**ADDENDUM NO. 2**

**DATE: 5-1-2024**

**TO: ALL BIDDERS**  
**FROM: JKF ARCHITECTURE**  
**RE:** Pitt Community College New Welding Building  
Project No. 2022-07

RE: Pitt Community College  
New Welding Building  
Addendum #2

h. Detail J18/FA0.0:

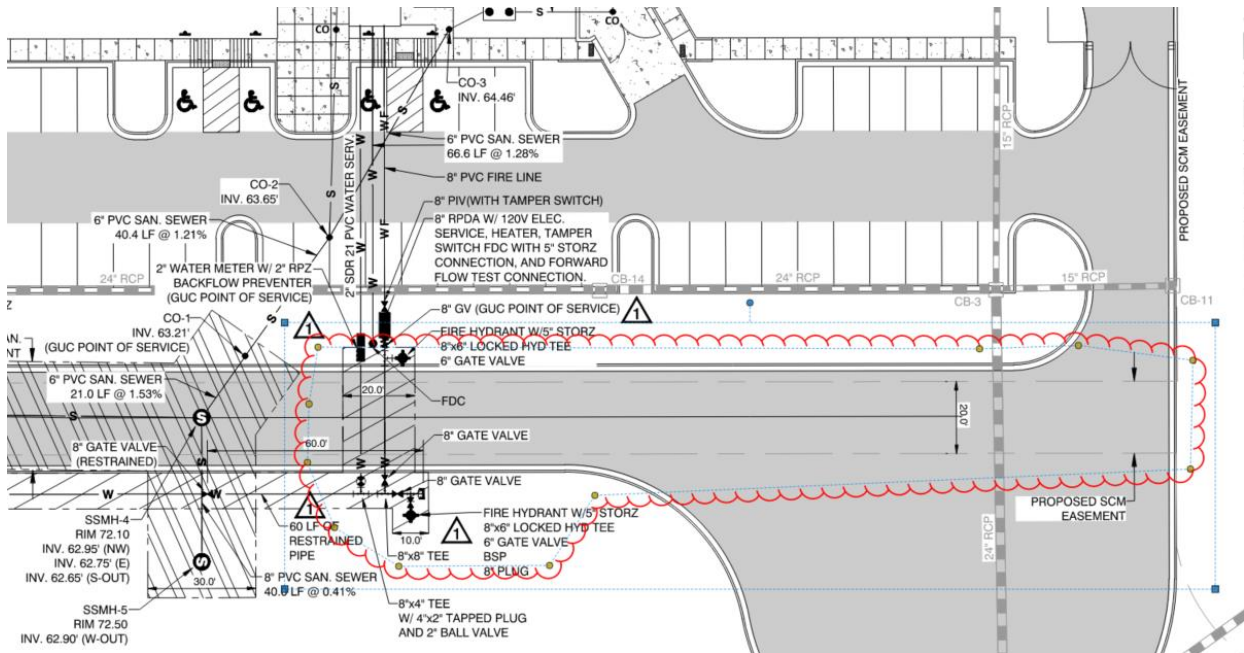
Required BDA monitor modules in BDA diagram shall be 8.

**PITT COMMUNITY COLLEGE WELDING BUILDING  
WATERLINE REVISION  
5-1-24**

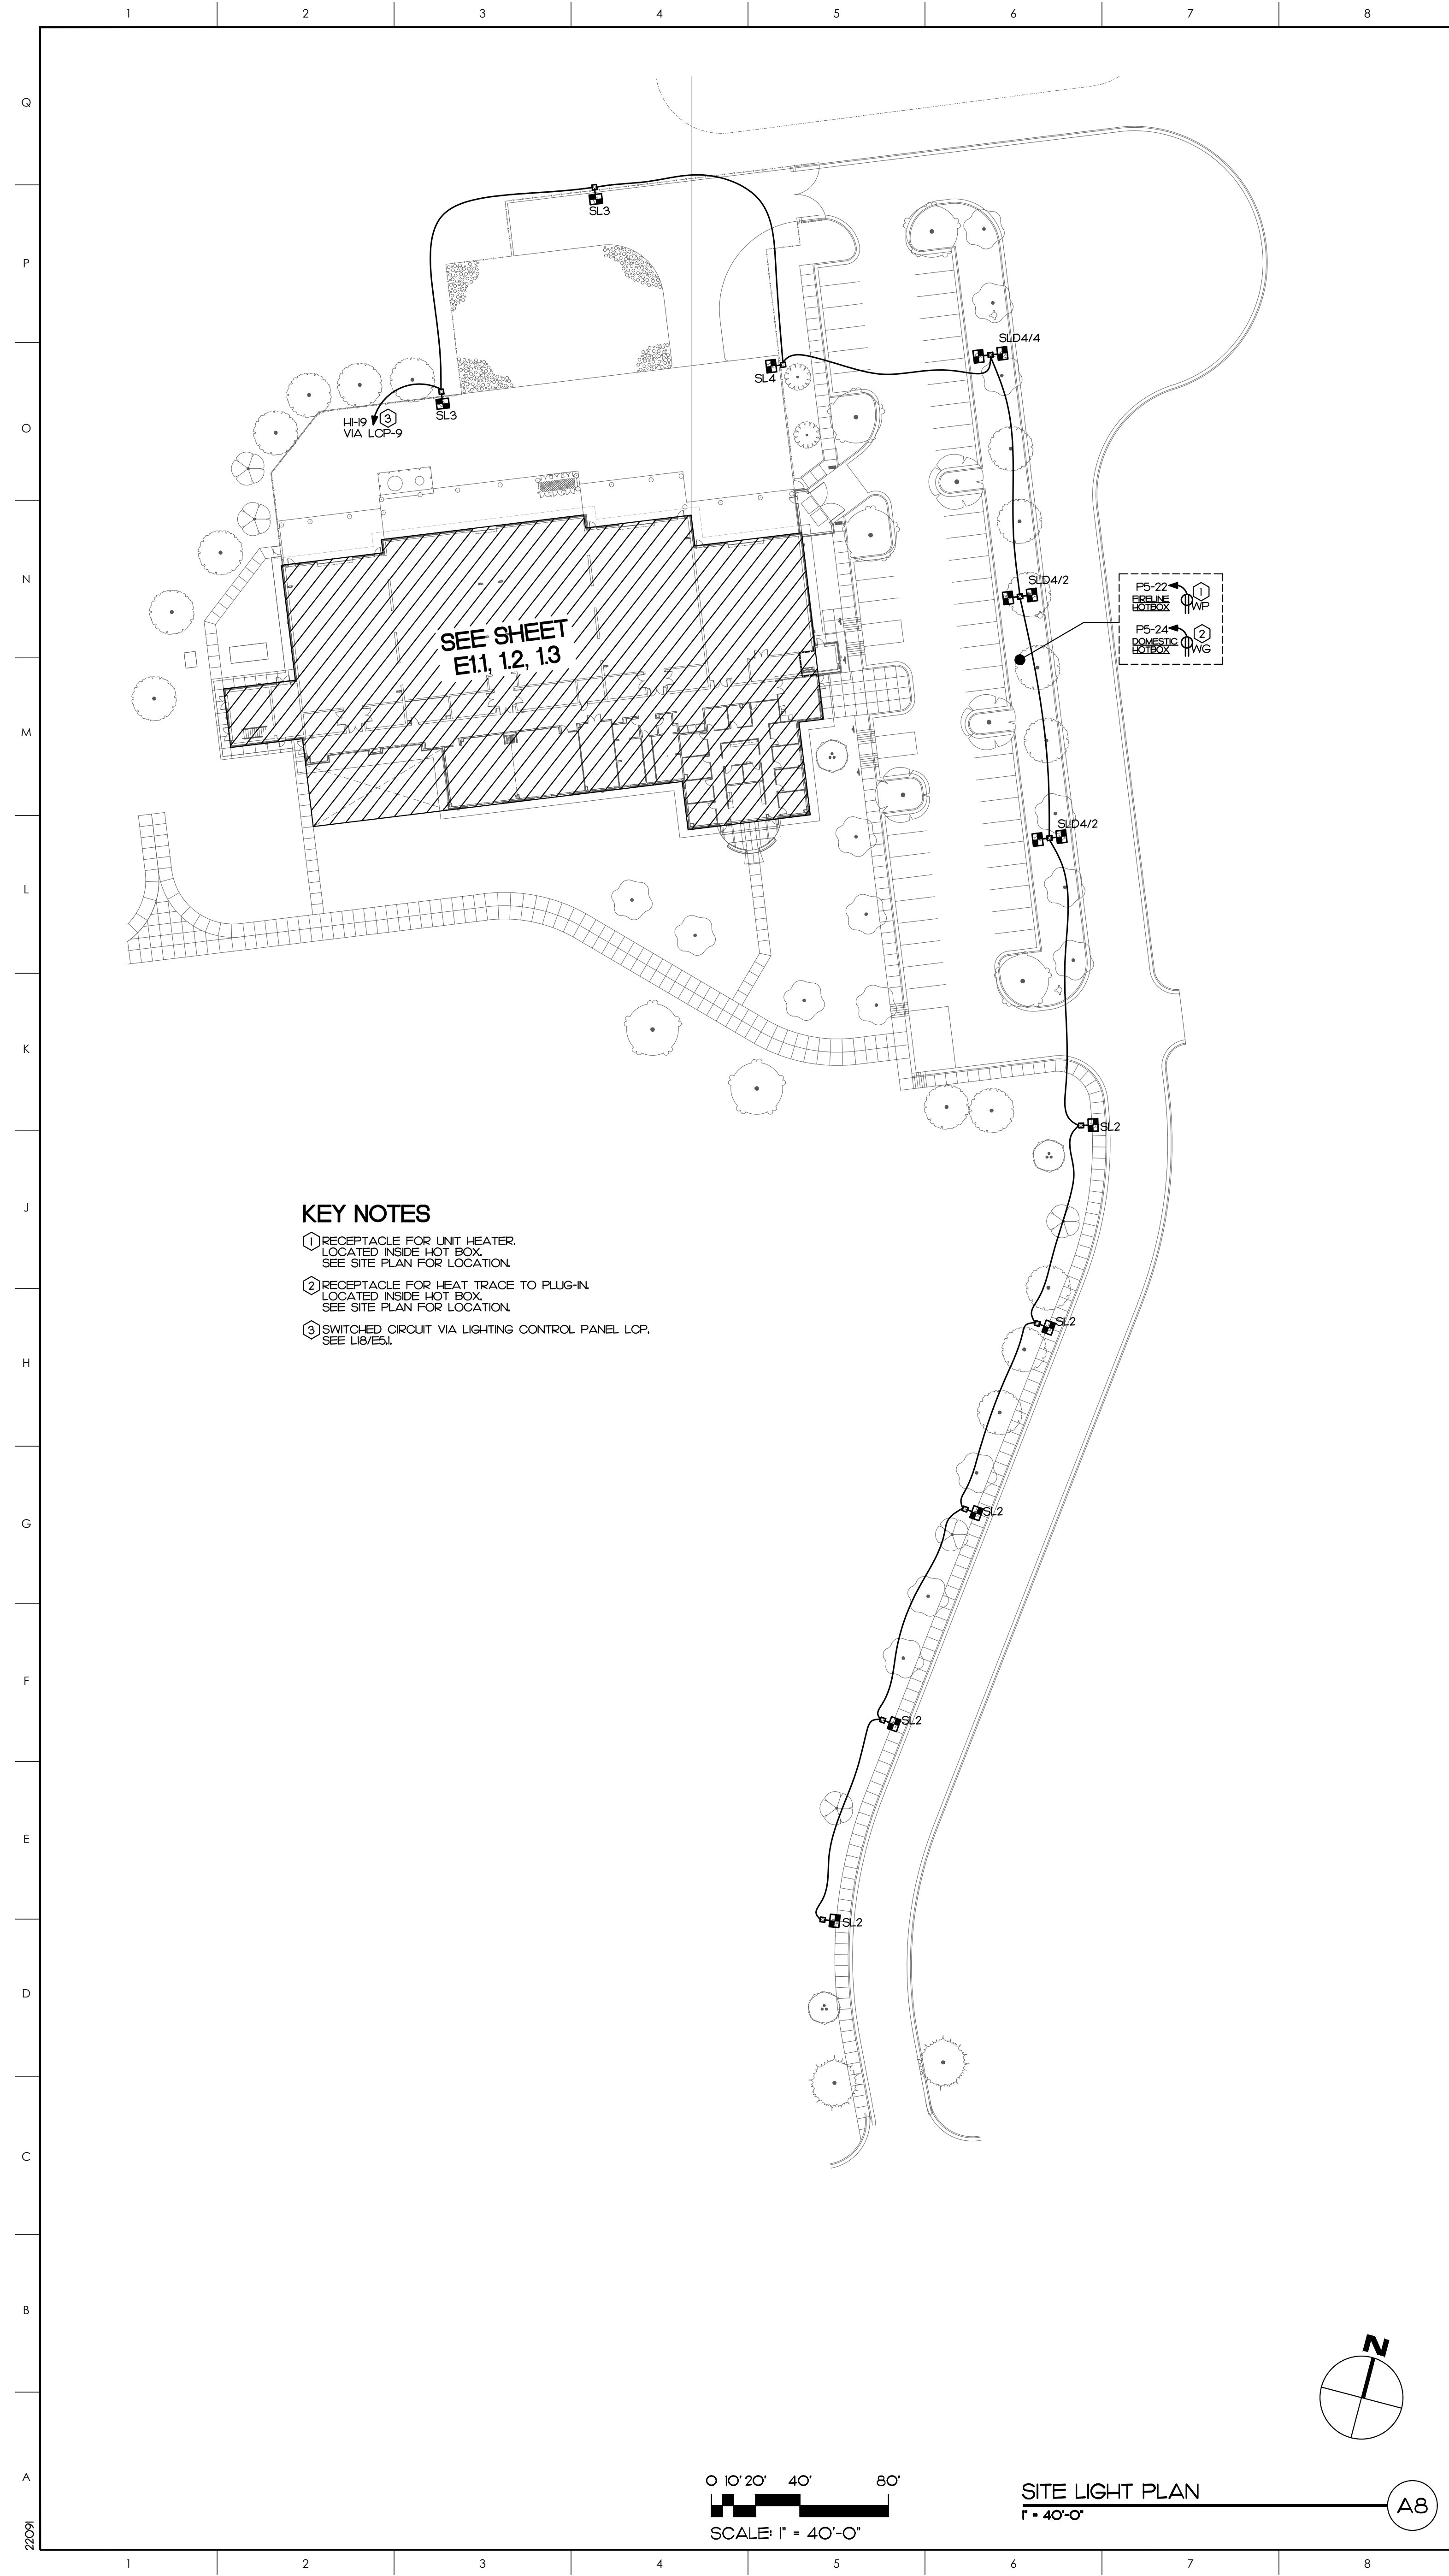
Greenville Utilities Commission required the removal of the waterline and relocation of fire hydrant to the proposed water service in order to eliminate water quality problems at the end of the line. The coverage was adequate with the fire hydrant relocation.

**E7.1**

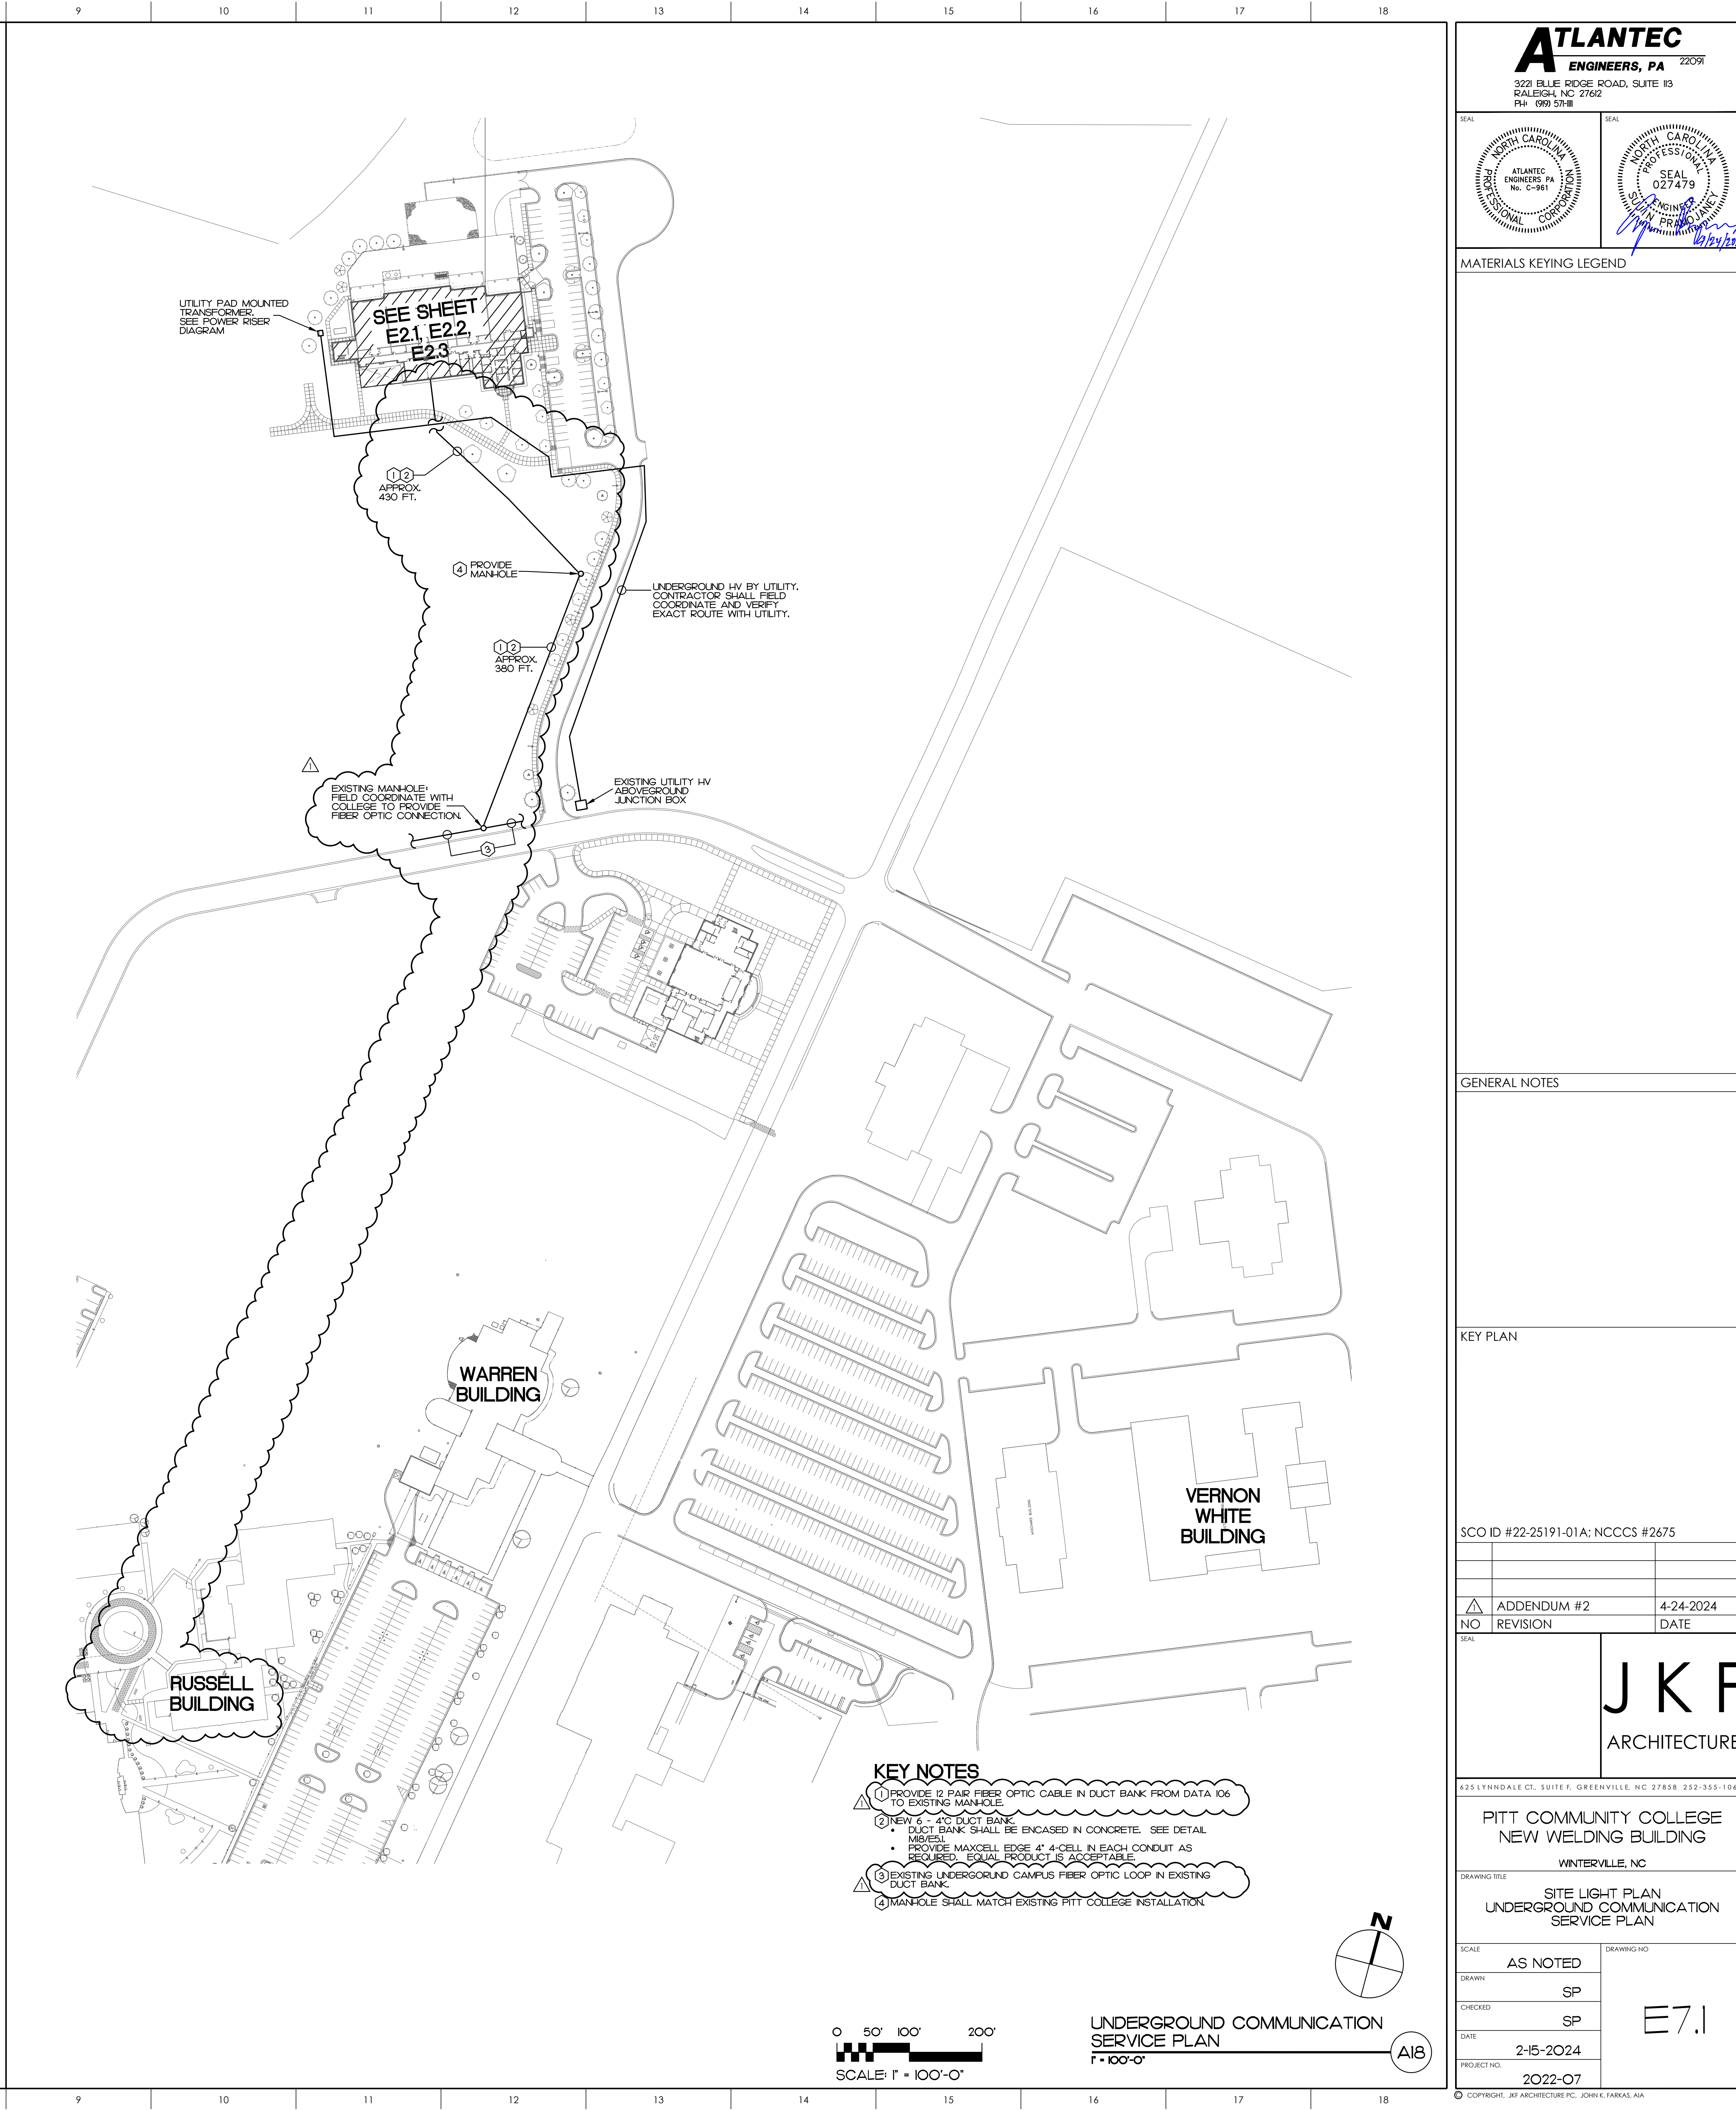
- e. Detail F18/E5.1: The following information shall replace the detail as follows:
- New underground fiber optic in communication service conduits shall be from DATA 106 to existing manhole (with campus fiber optic pass-through) near road. See revised detail A18/E7.1 for location. Wiring to existing Russell building is not required.

- One new manhole is required between the building and the existing manhole. Field coordinate with college IT department to provide connection at the existing manhole. Terminate fiber optic cable from the building at the existing manhole per the college IT department instruction.

- Contractor shall provide protection for all existing installation inside the existing manhole during construction. Any damage to existing installation is the contractor responsibility.

- KEY NOTES**
- ① PROVIDE 12 PAIR FIBER OPTIC CABLE IN DUCT BANK FROM DATA 106 TO EXISTING MANHOLE.
  - ② NEW 6 - 4" DUCT BANK. DUCT BANK SHALL BE ENCASED IN CONCRETE. SEE DETAIL M16/EN1. PROVIDE MAXCELL EDGE 4" 4-CELL IN EACH CONDUIT AS PROVIDED. EQUAL PRODUCT IS ACCEPTABLE.
  - ③ EXISTING UNDERGROUND CAMPUS FIBER OPTIC LOOP IN EXISTING DUCT BANK.
  - ④ MANHOLE SHALL MATCH EXISTING PITT COLLEGE INSTALLATION.
